Lakeside Farms Elementary – ESS Relocatable

Bid #: 2024-03C

Lakeside Union Elementary School District

ADDENDUM 01

C-3.0

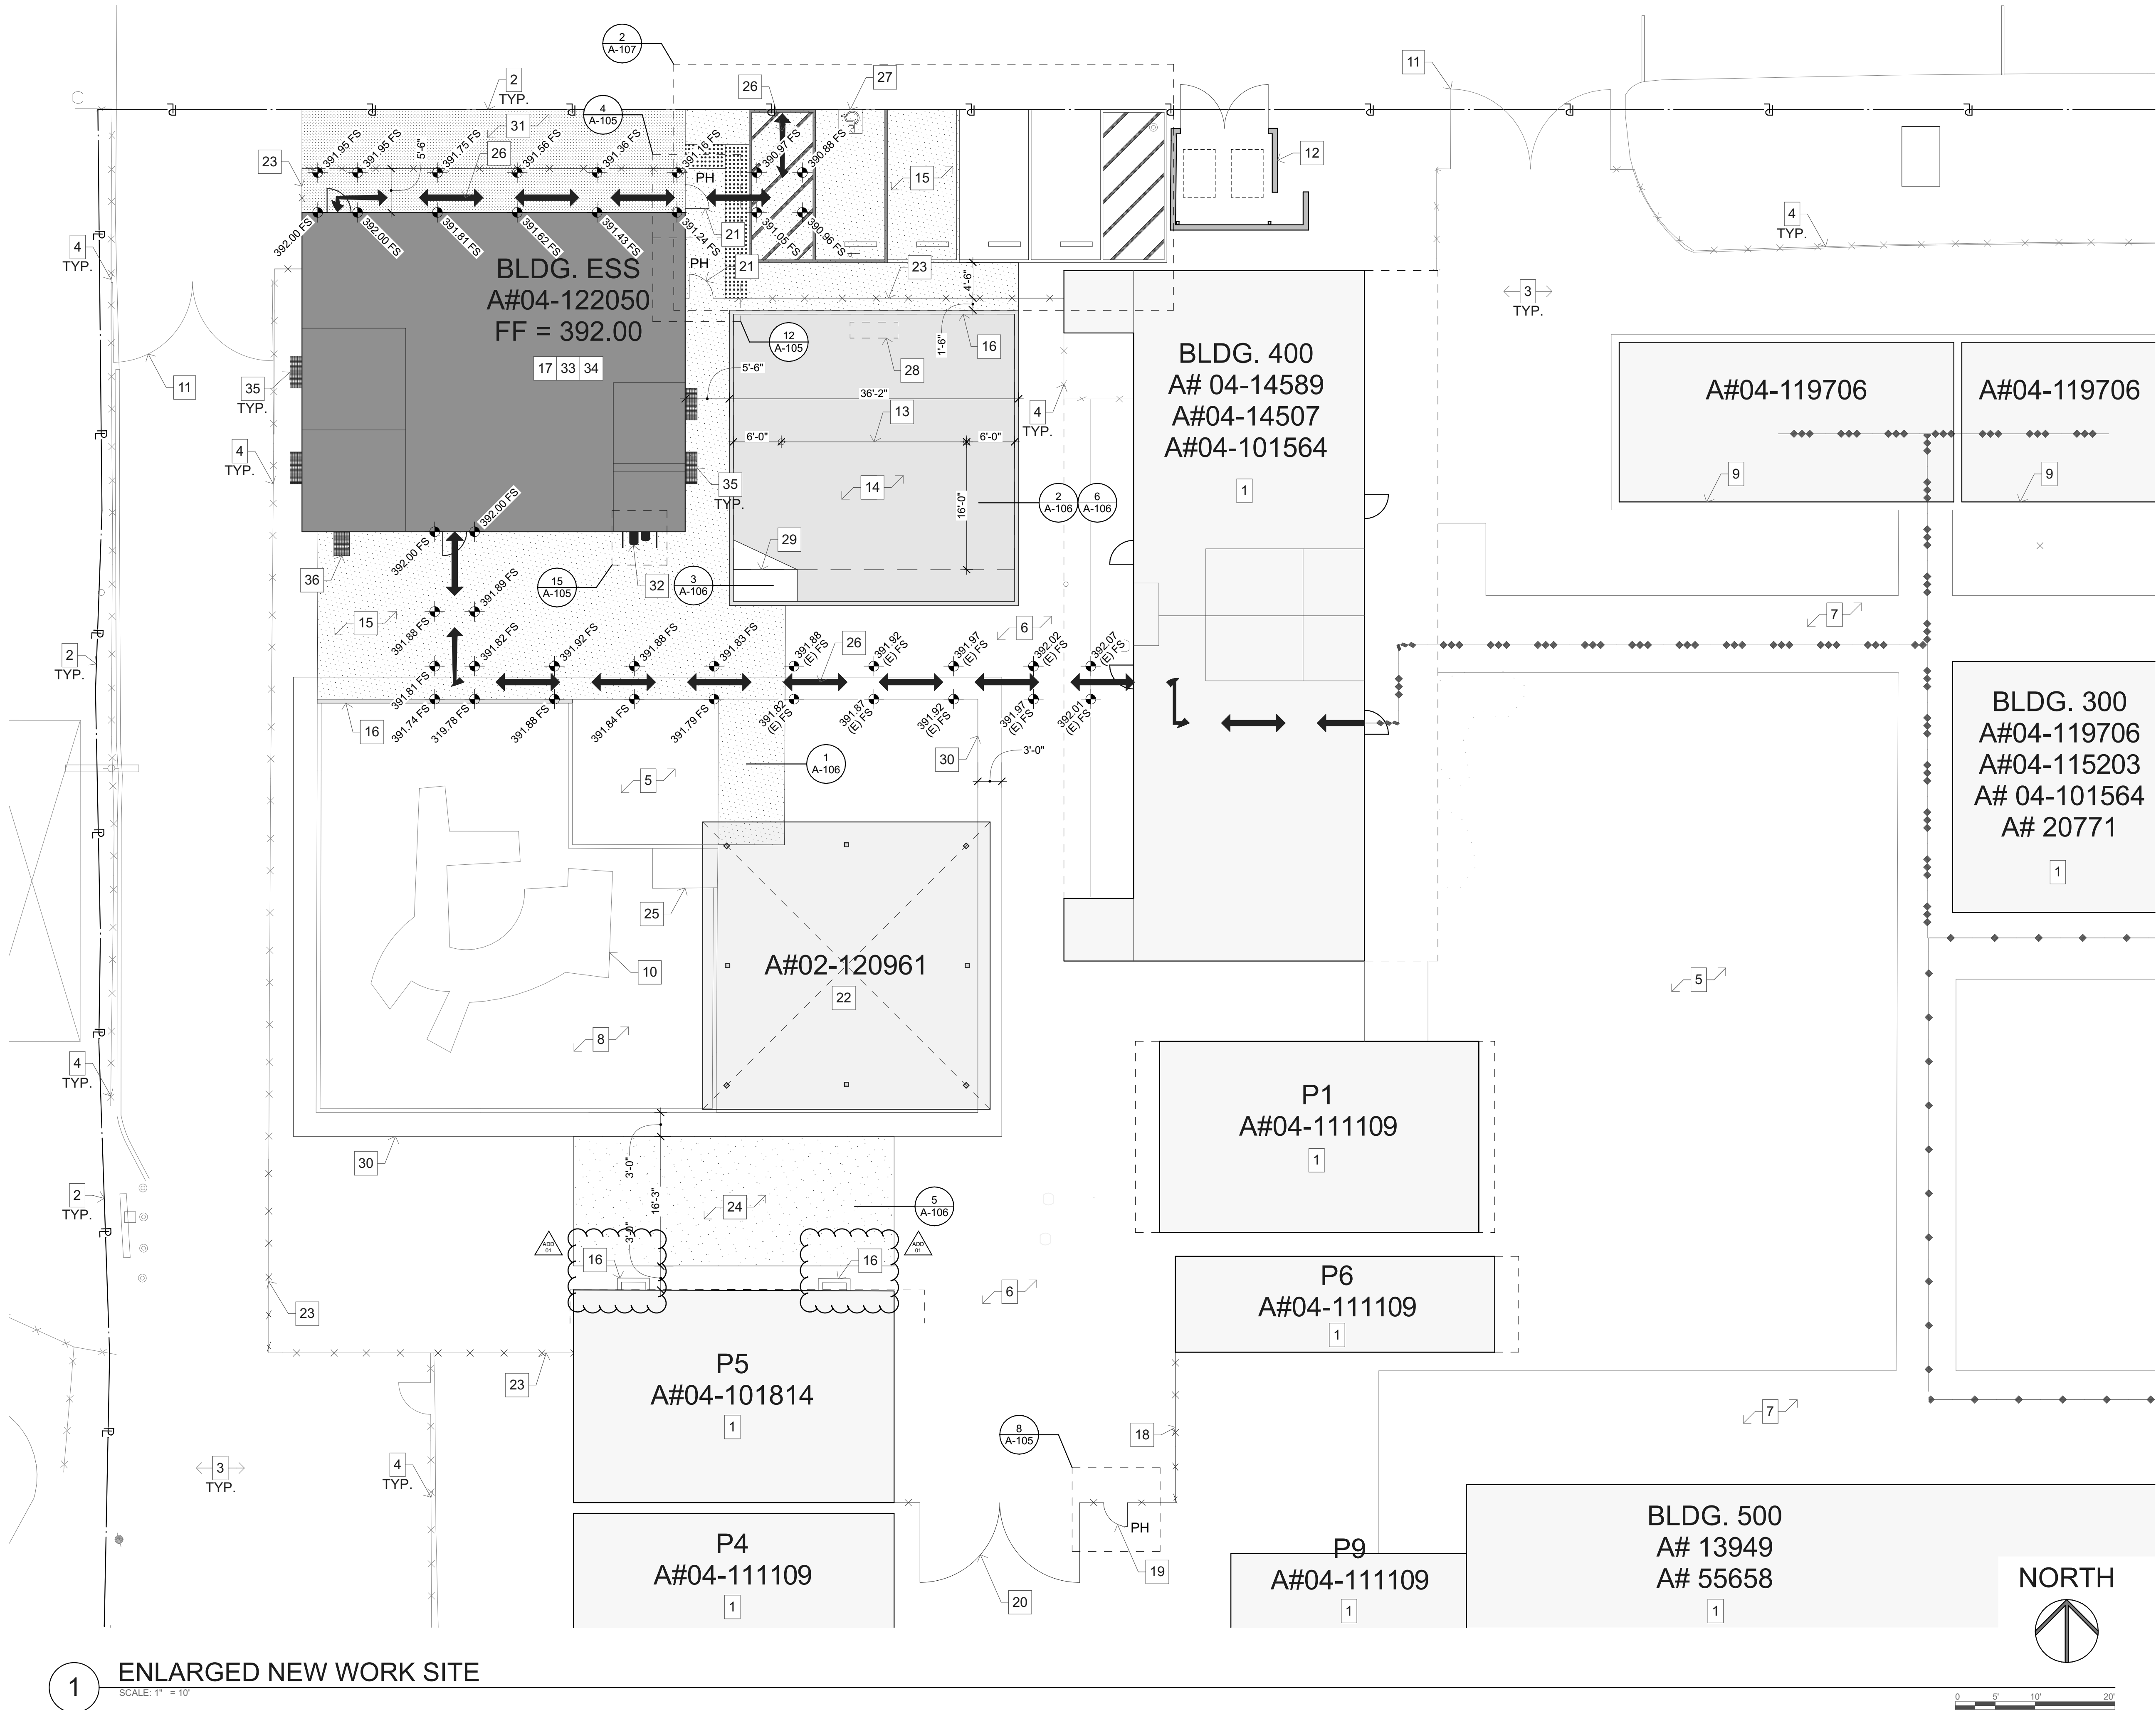
- Item #3. REVISION – Erosion Control Plan C-03
 - a. Replotted sheet to show site plan revisions, no updates to erosion control plan.
- Item #4. ADDITION – Details C-04

A-104

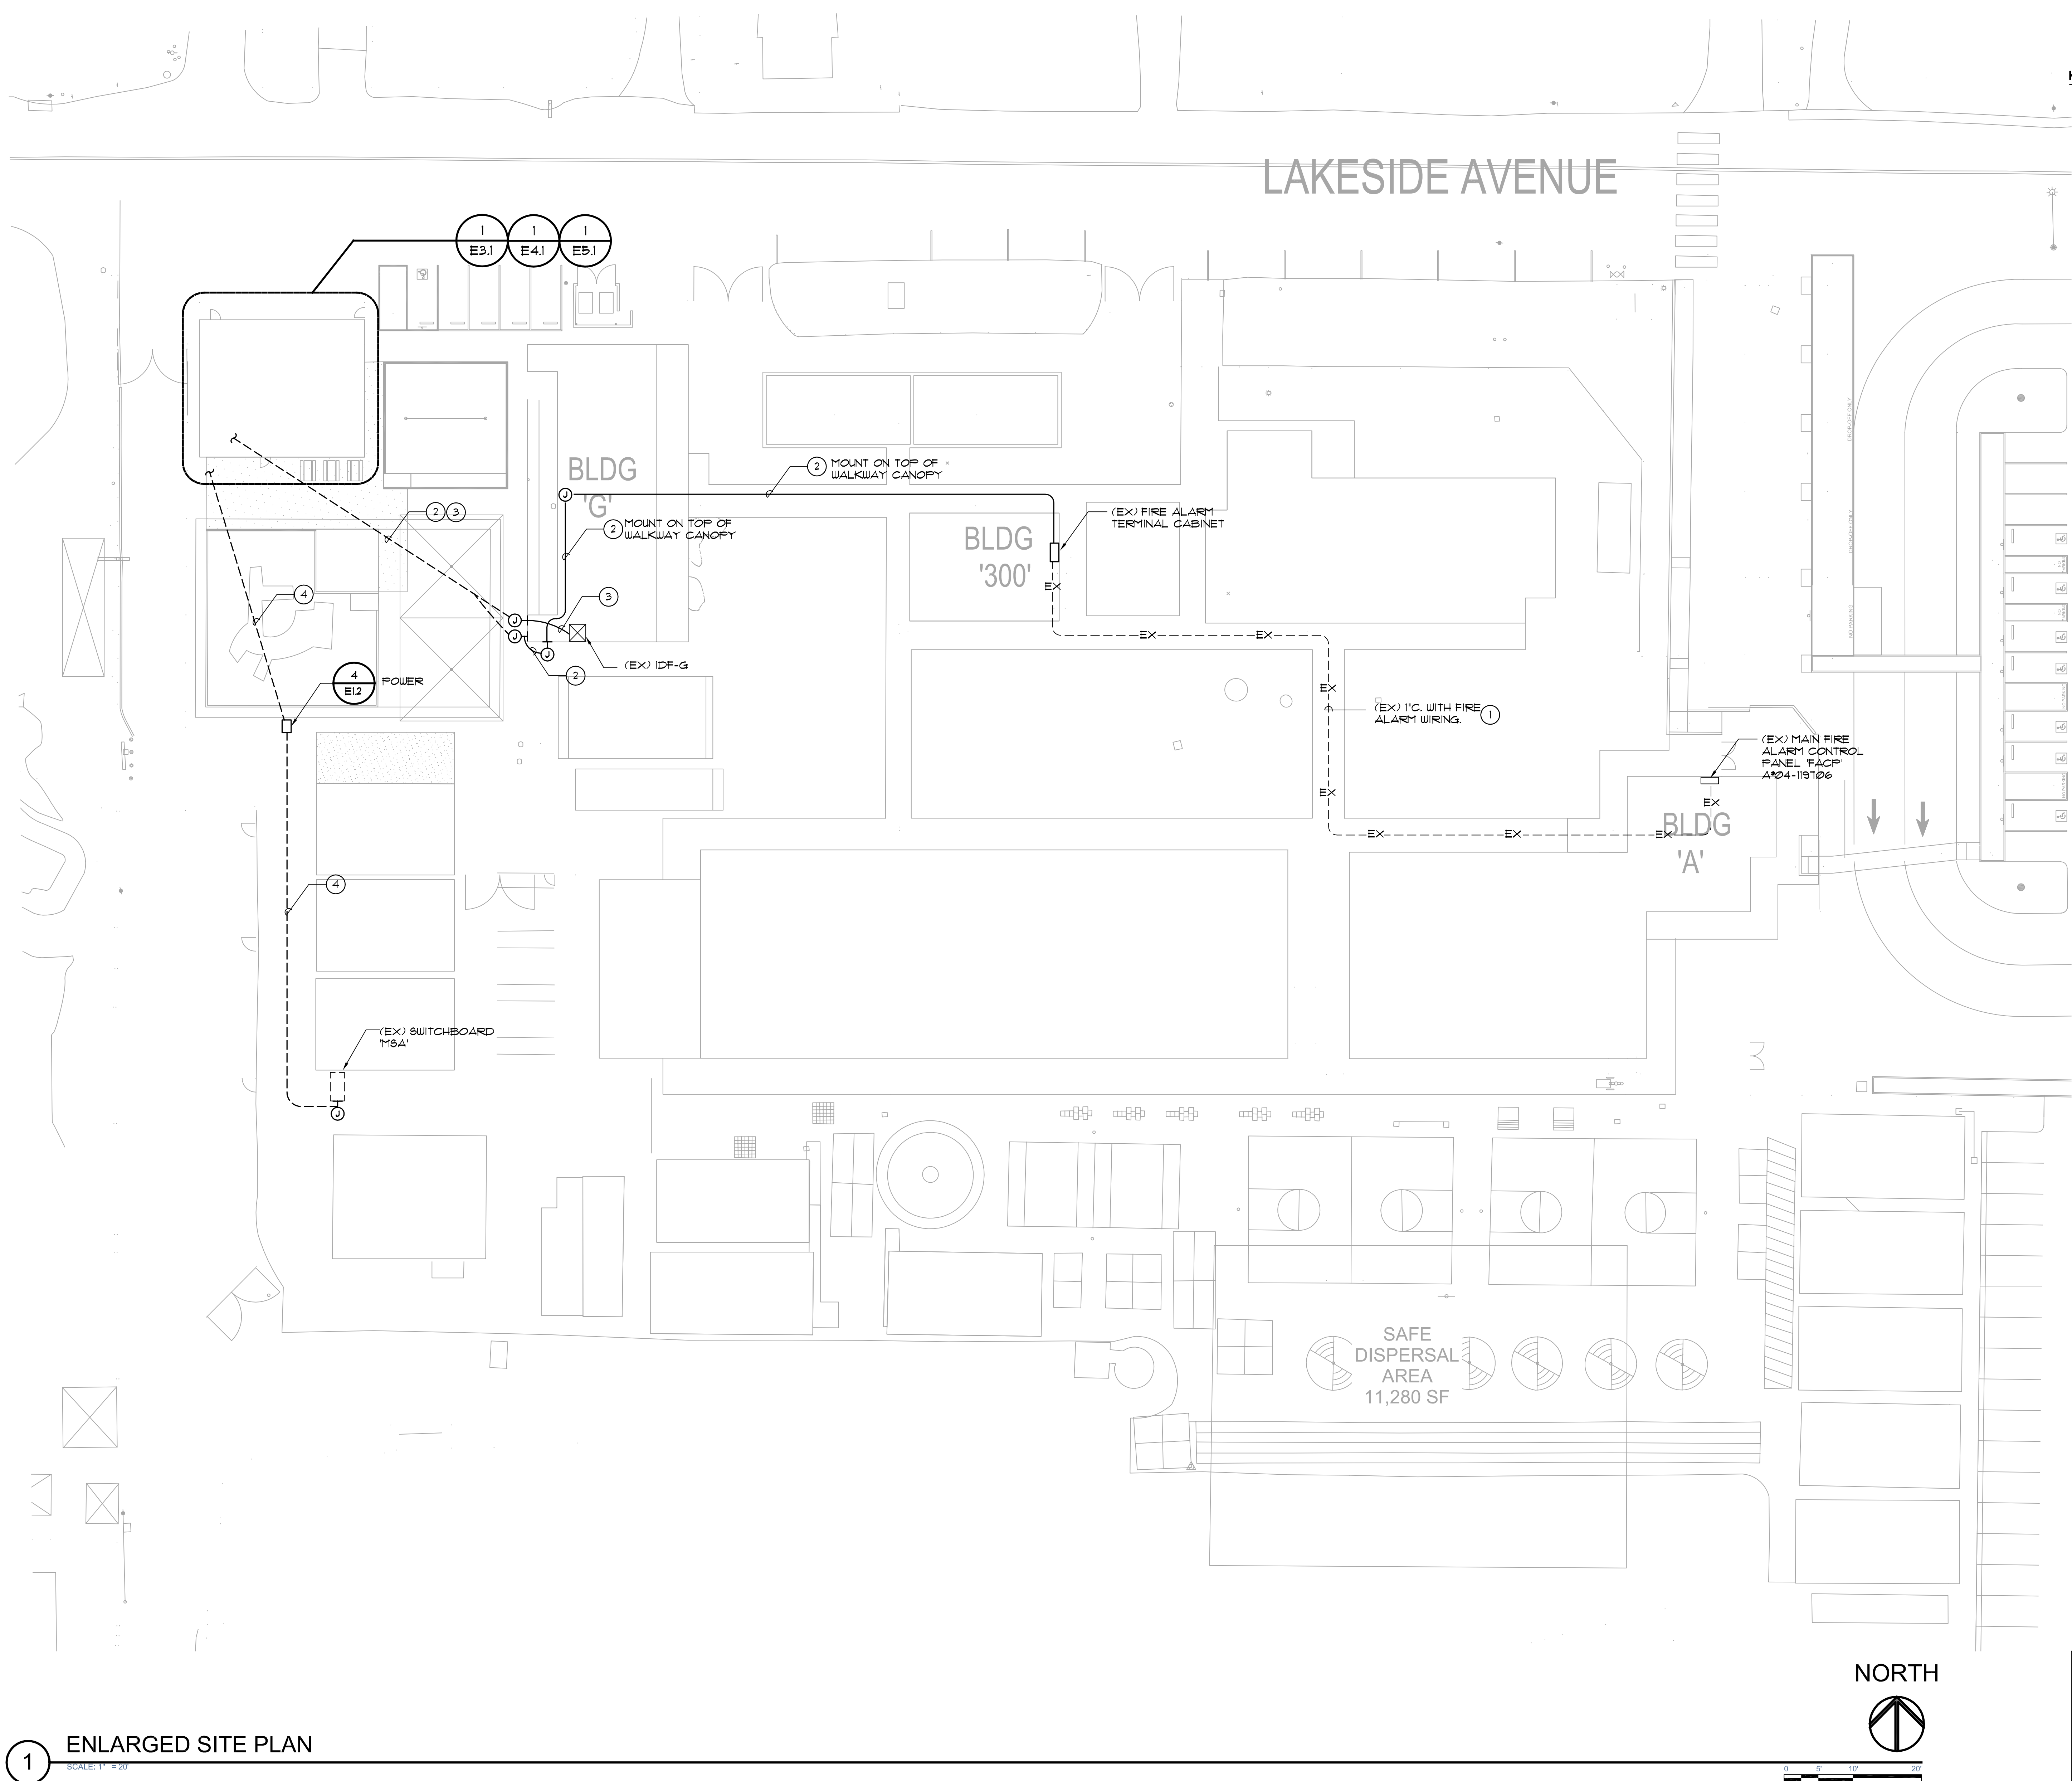
- a. Added details for thrust blocks for domestic water line.
- Item #5. ADDITION – Enlarged Site New Work Plan A-104
 - a. Added (2) new 6" concrete curbs surrounding existing relocatable wall vents. Keynote 16 provided in several locations on plan.

E-1.1

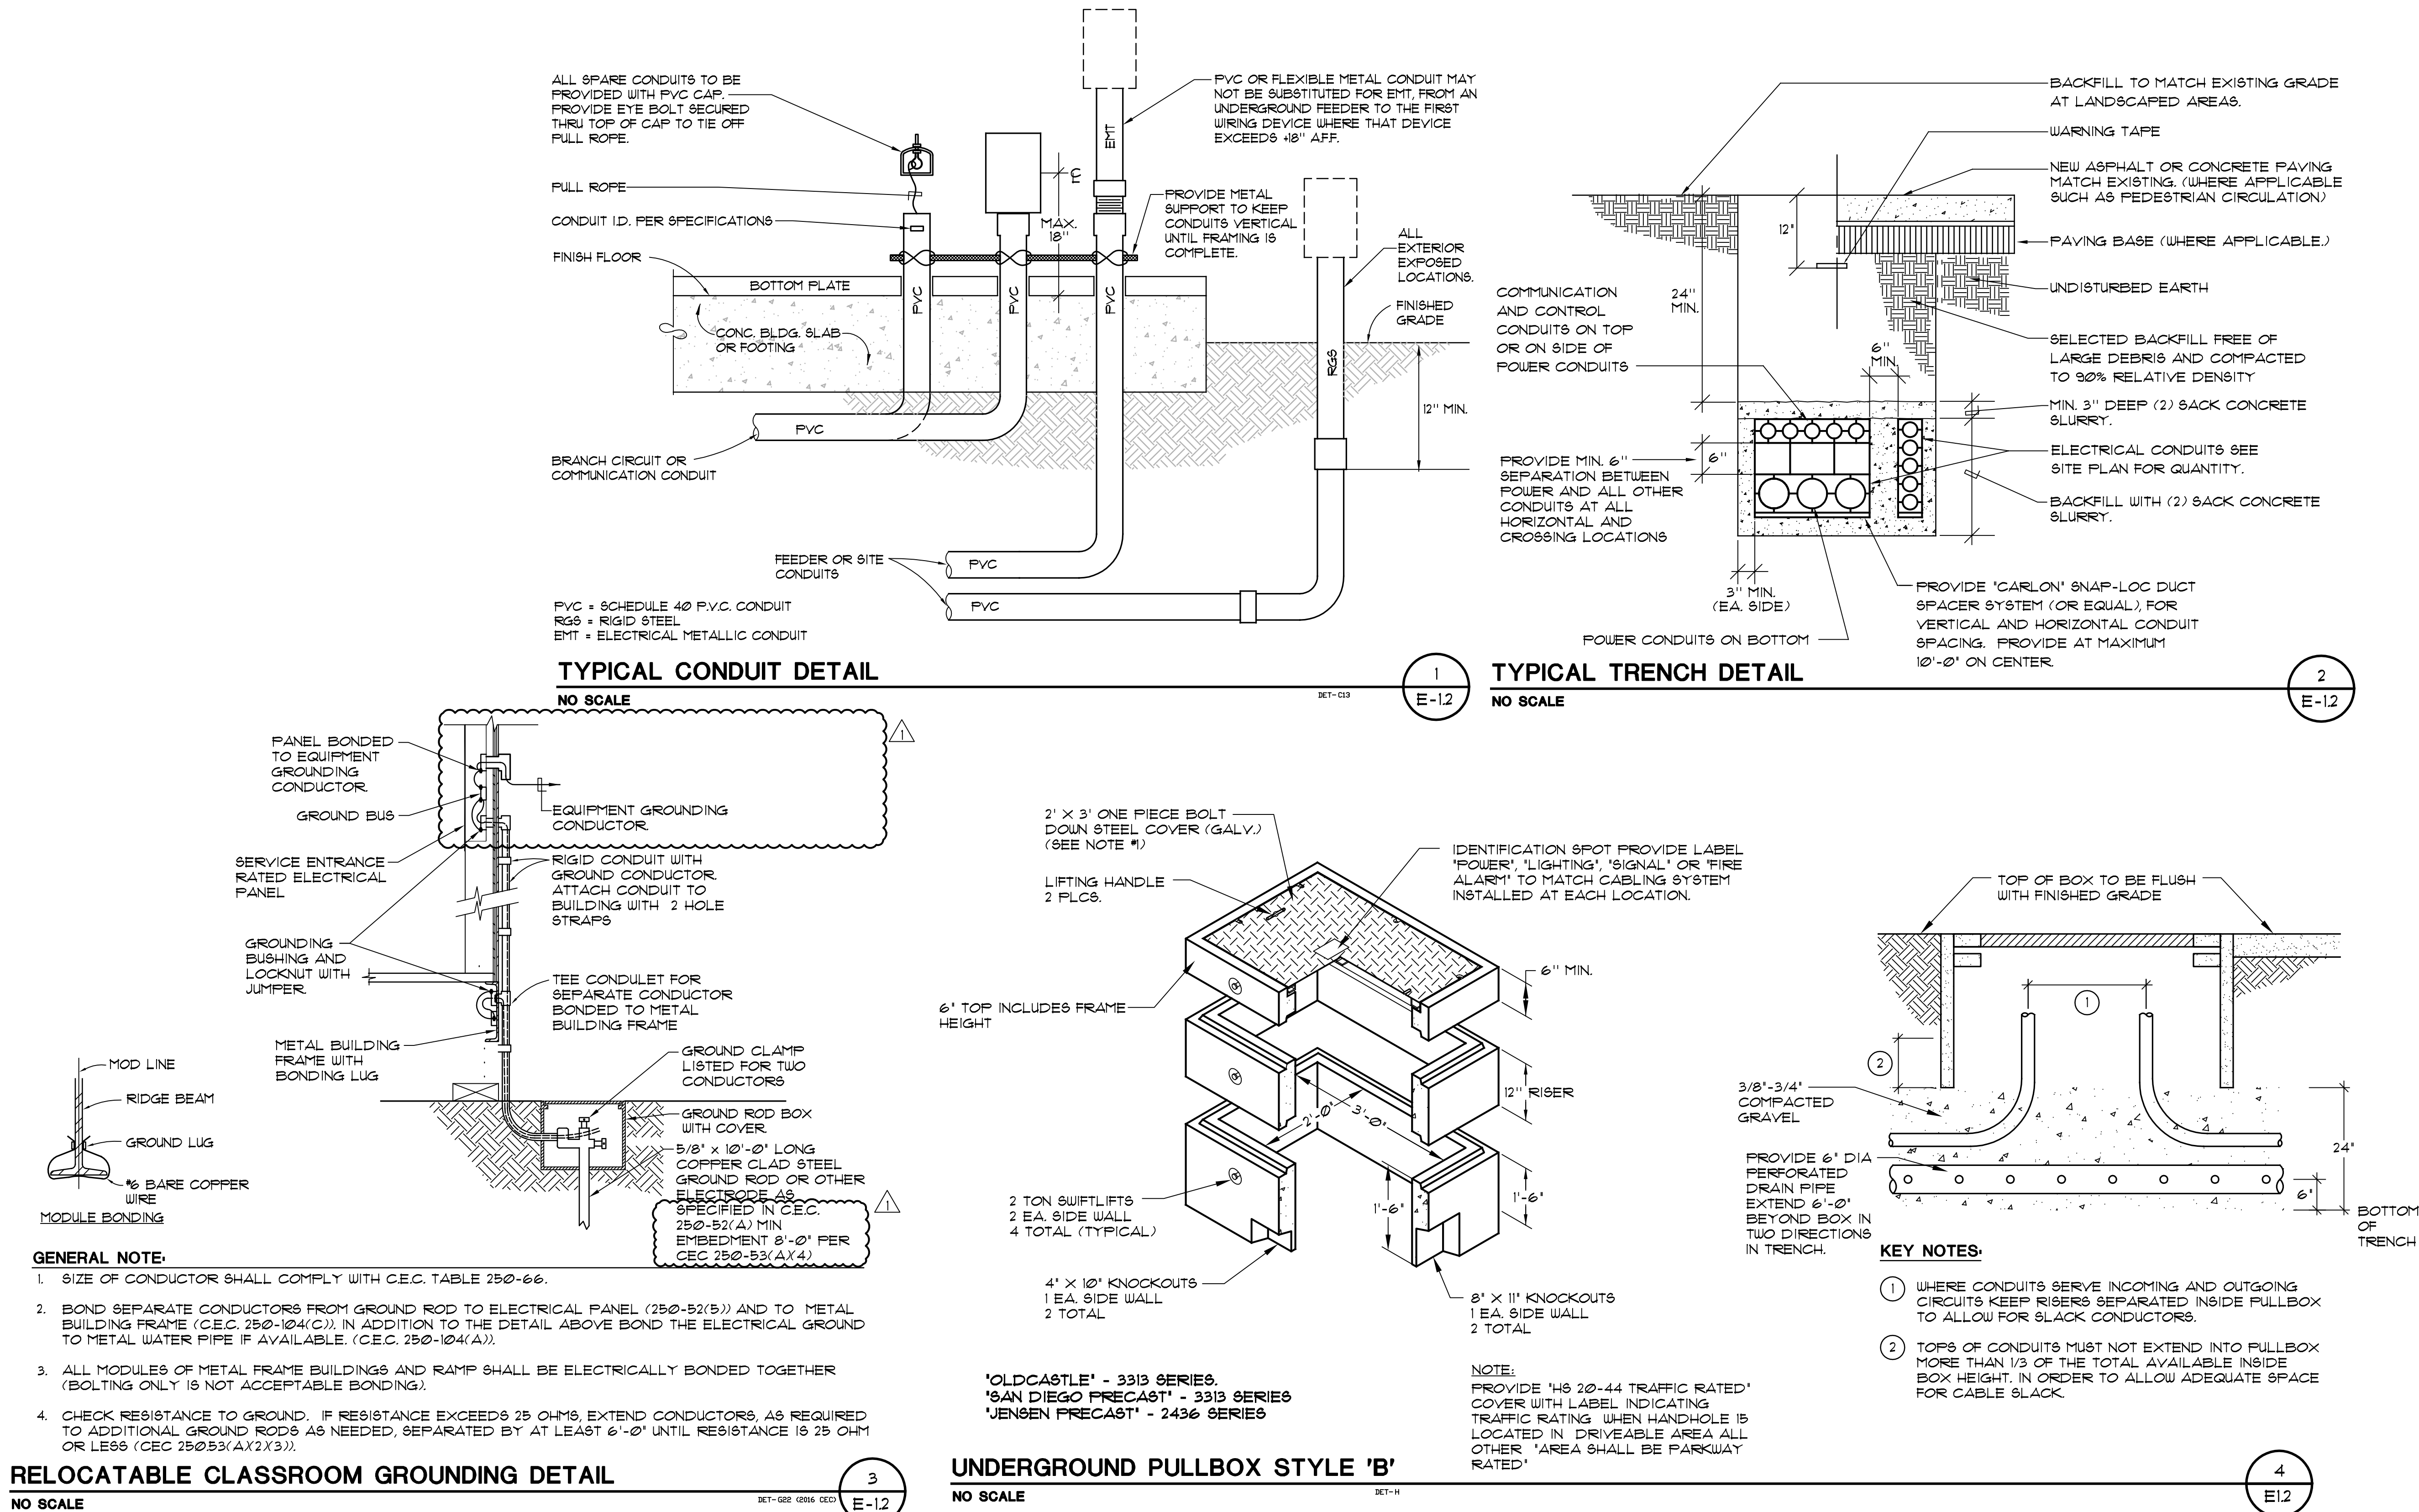
- Item #6. REVISION – Overall Site Plan E-1.1
 - a. Reduced site power conduit size due to deletion of one panelboard in the building per AMS drawings.
- Item #7. REVISION – Electrical Details E-1.2
